STAFF RECOMMENDATION
102 South 14th Street
July 21, 2021

Application: New Construction—Addition; Partial Demolition
District: Lockeland Springs-East End Neighborhood Conservation Zoning Overlay
Council District: 06
Base Zoning: R6
Map and Parcel Number: 08309026500
Applicant: Hunter Conley, Allard Ward Architect
Project Lead: Melissa Baldock, melissa.baldock@nashville.gov

<p>Description of Project: Application is to construct a rear addition and partial demolition.</p> <p>Recommendation Summary: Staff recommends approval of the project with the following conditions:</p> <ol style="list-style-type: none"> 1. The window on the front-facing gable be widened to match the size of the historic opening, the dimensions of which likely still exist under the vinyl siding; 2. On the front part of the right side façade, the windows be vertically-oriented and have a height that matches the height of the window to their right; 3. Staff assess the historic siding on the house once all of the vinyl has been removed to see what pieces of siding can be retained in the renovation; 4. Partial-demolition be accomplished manually, and a partial-demolition and shoring plan be submitted prior to the per

Figure 3. The shed roof portion of the rear of the house will be removed as part of the project.

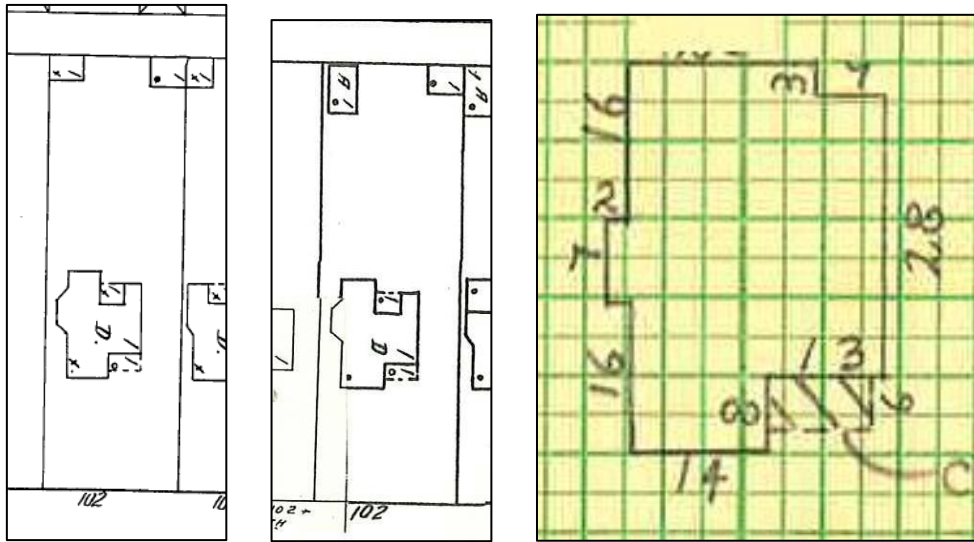
The applicant plans to remove an existing rear addition with a shed roof (Figure 3). The addition's date of construction is sometime between 1957 and 1968 because it appears in the c. 1968 Property Assessor footprint but does not appear on either the 1914 or the 1957 Sanborn map (Figures 4, 5, 6). The addition's date of construction and separate roof form do not contribute to the historic character of the house and staff therefore finds that its removal meets the design guidelines.

Figure 7 (Left) shows the proposed new window opening on the front façade and Figure 8 (Right) shows the existing condition.

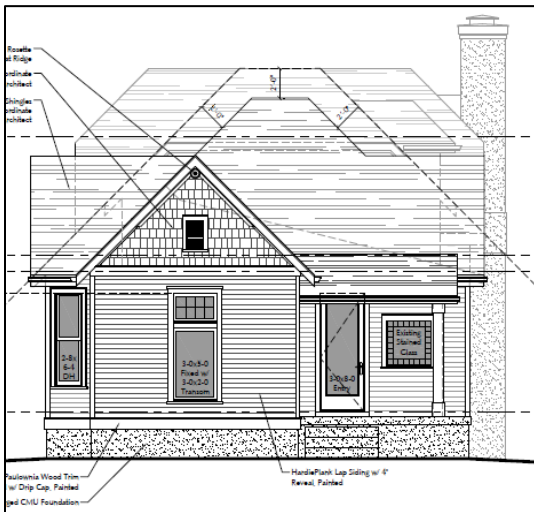
The applicant also intends to alter the window openings on the front and side facades, which is considered partial demolition. On the front façade, the applicant intends to alter the main front window, which is not historic (Figures 7 & 8). The c. 1968 photo shows a larger window opening with a transom, and a c. 1986 photo shows that opening shortened (Figures 9 & 10). The proposed new window opening seems narrower than the window that is seen on the c. 1968 and c. 1986 photos. Staff recommends that opening on the front wall be widened to match the dimensions of the window that was there historically. Once the vinyl siding is removed, the architect can measure the original window opening. With this condition, staff finds that this partial demolition to meet the design guidelines because it is restoring an historic condition documented with photos.

1. The window on the front-facing gable be widened to match the size of the historic opening, the dimensions of which likely still exist under the vinyl siding;
2. On the front part of the right side façade, the windows be vertically-oriented and have a height that matches the height of the window to their right;
3. Staff assess the historic siding on the house once all of the vinyl has been removed to see what pieces of siding can be retained in the renovation;
4. Partial-demolition be accomplished manually, and a partial-demolition and shoring plan be submitted prior to the permit being issued;
5. Staff approve all windows, doors, and roof shingle color prior to purchase and installation; and
6. The HVAC be located behind the house or on either side, beyond the mid-point of the house, and utility meters shall be located on the side of the building, within 5'

Figures 11 & 12. Show the existing conditions. Two windows will be added on the wall in the left photo. The two windows on the bay will be elongated and the window with the arrow pointing to will be altered

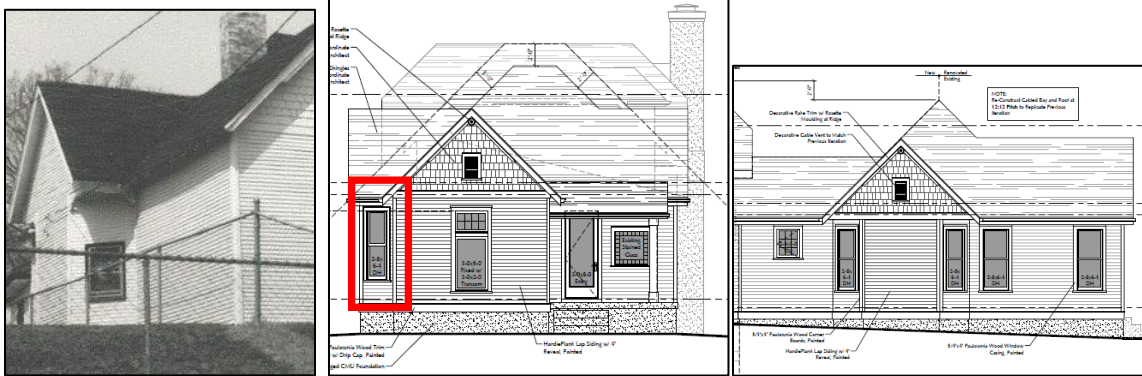
Several changes are planned for the window openings on the side facades. On the right façade, the applicant will be adding window openings to the front, elongating the windows on the bay, and changing the windows at the back (Figures 11-15). Staff finds that adding windows on the left façade to be appropriate even though the 1986 façade does not show windows in this location because historically, it was common to have windows on a façade like this one. In addition, the window proportions proposed for this façade are in keeping with windows openings on early twentieth century Folk Victorian houses like this one.

Similarly, even though the 1986 photo shows the window in the bay to be short like the existing window, the elongated windows are more in keeping with the proportion of windows openings that are found on houses of this style and date of construction. In addition, bays typically were primarily glazing. It is likely that the window that is there now and seen in the 1986 photo is not original. Lastly, staff finds that altering the window opening behind the bay is appropriate because it is at the back part of the historic house and not visible from the street due to the bay and because of the slope of the lot.

First Floor Plan

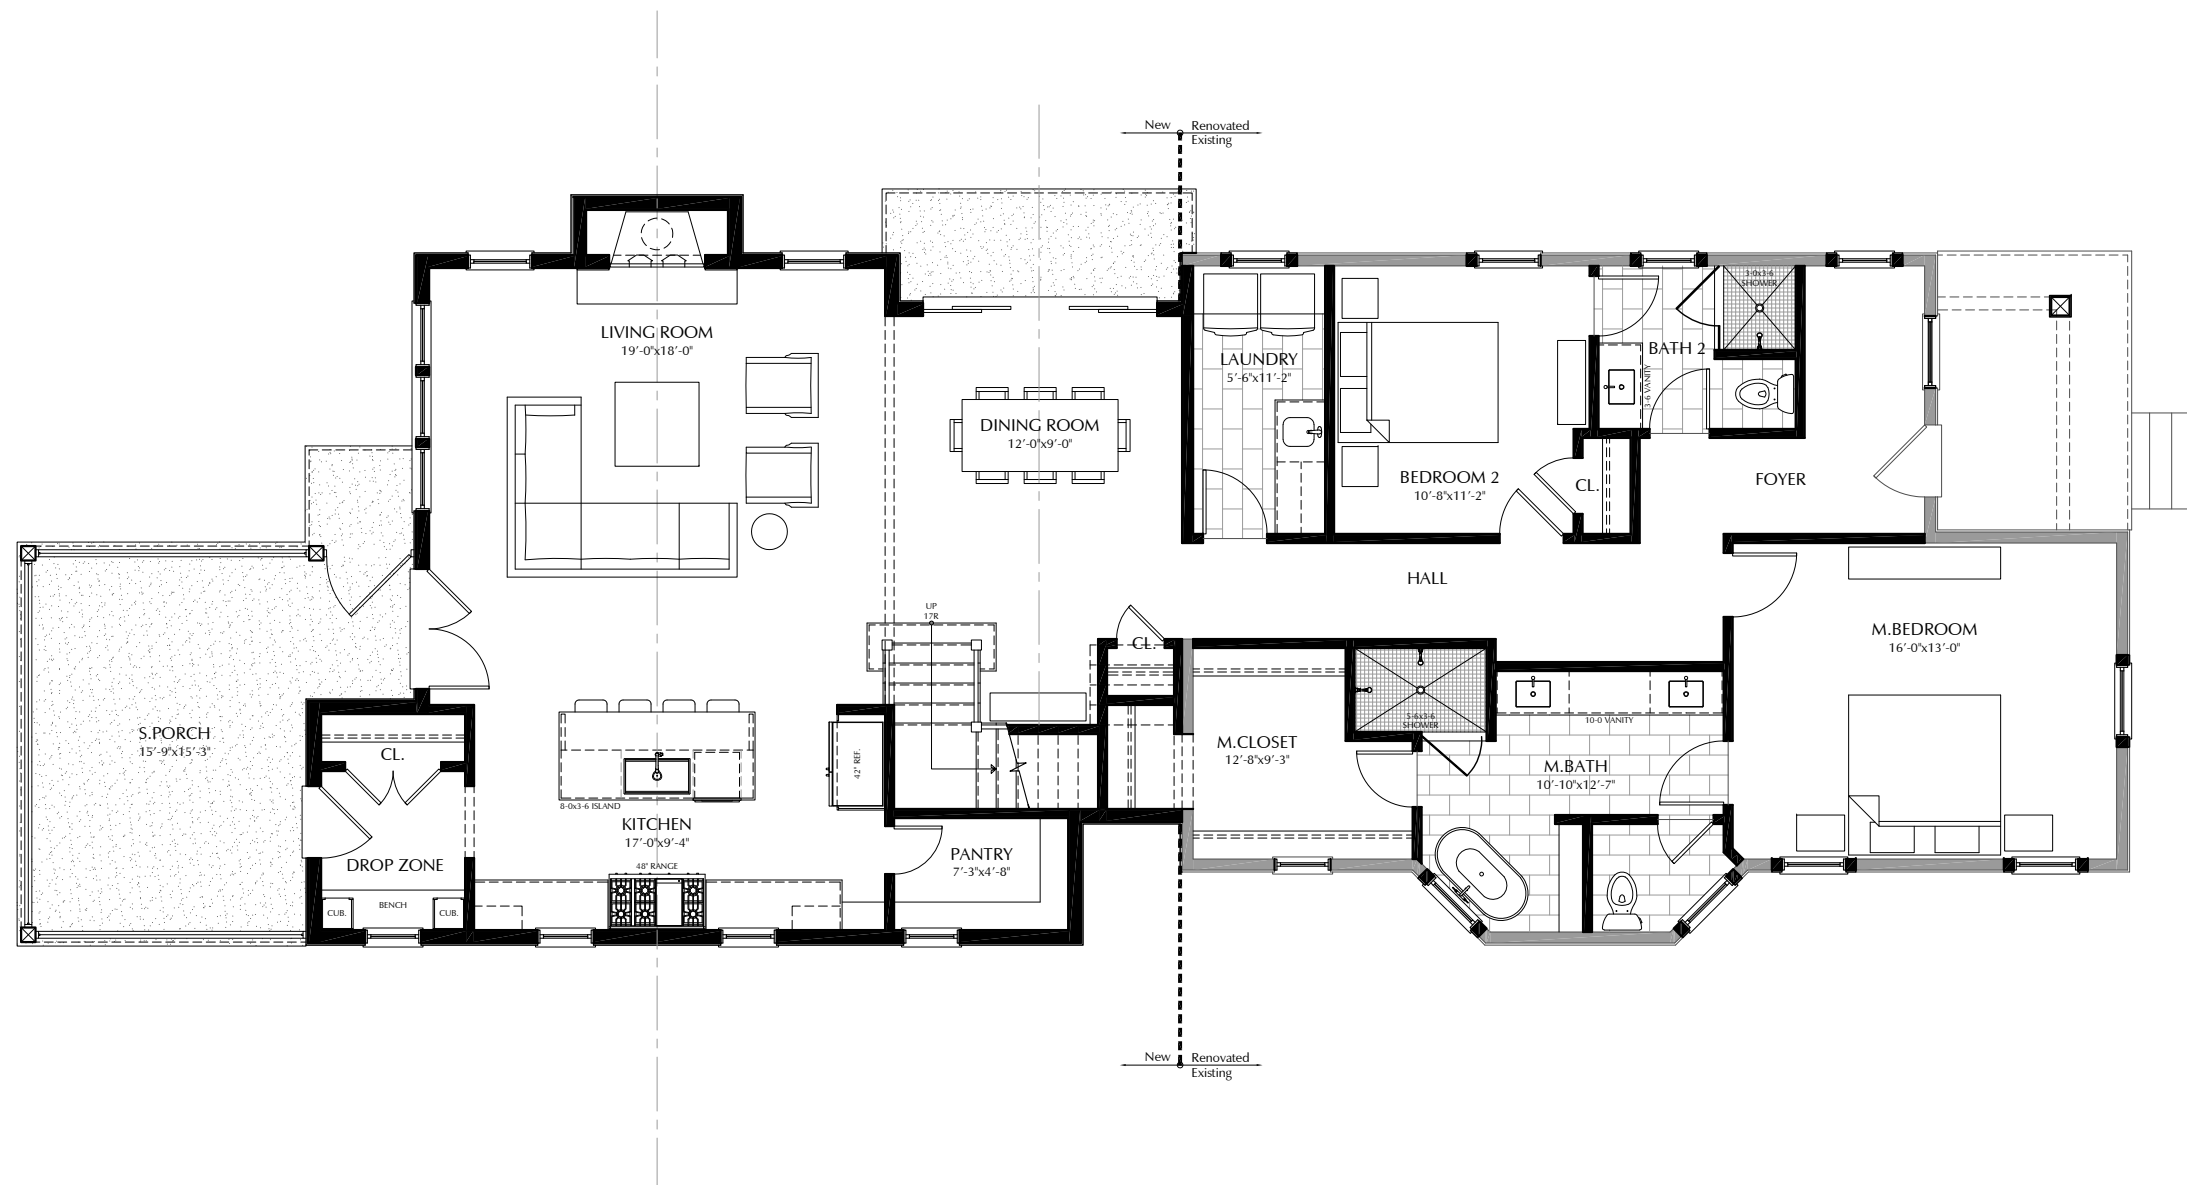
The addition is inset two feet (2') from both back corners, which meets the design guidelines. On the right side, the addition has a two foot by eleven foot, six inch (2' X 11'6") alcove. After the alcove, the addition steps back out to line up with the side wall of the historic house. On the left side, the addition is inset two feet (2') for a depth of four feet (2'). After this alcove, the addition steps back out to line up with the side bay of the house. Typically, an addition should line up with the main wall of the house, unless the addition includes a bay, and that bay can line up with the historic bay. However, staff finds the fact that the wall of the first floor of the addition lines up with the bay to be

appropriate because the historic house's primary form is less than twenty-six feet (26') in width and even with the bay and the house is less than thirty feet (30') wide, which is narrow compared to the historic context. Also, the portion of the addition that lines up with the wall of the bay is just one story in scale and has an eave height that matches that of the historic house. Because of the narrowness of the historic house and the eave height of the addition on the left facade, staff finds that first floor footprint on the left facade is appropriate.

First Floor Demolition Plan

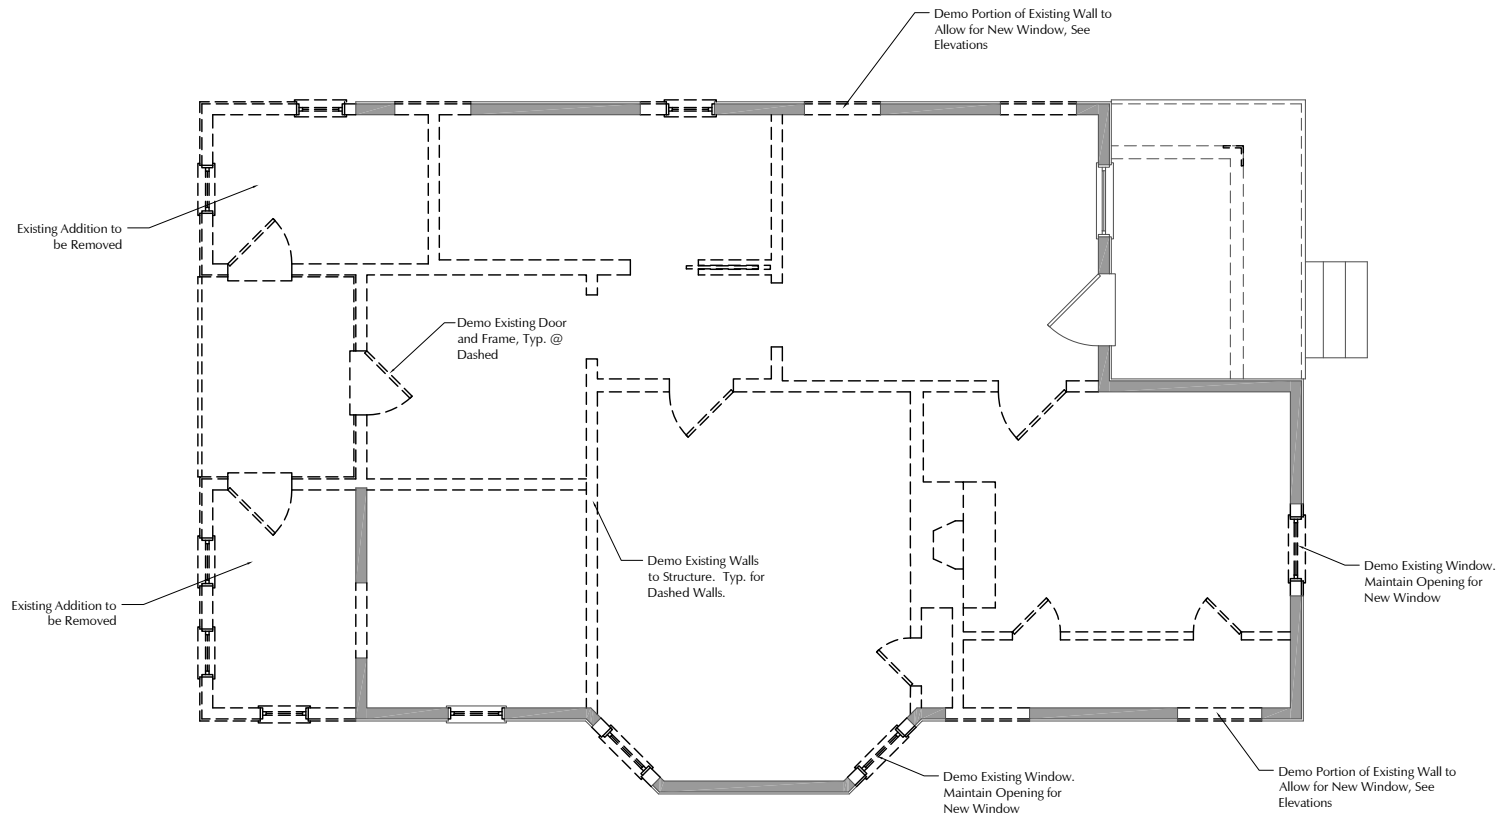
Partial Demolition: The applicant intends to remove non-historic additions to the house, alter window openings, and remove the siding, all of which are considered partial demolition.

Because the project involves substantial partial demolition, staff recommends a condition that the partial demolition is accomplished manually, and the applicant be required to submit a demolition and shoring plan.

With the conditions that partial demo is accomplished manually, that applicant submits a partial demo and shoring plan, and that staff review the historic siding prior to removal, staff finds that the proposed partial demolition meets Section III.B.1. of the design guidelines.
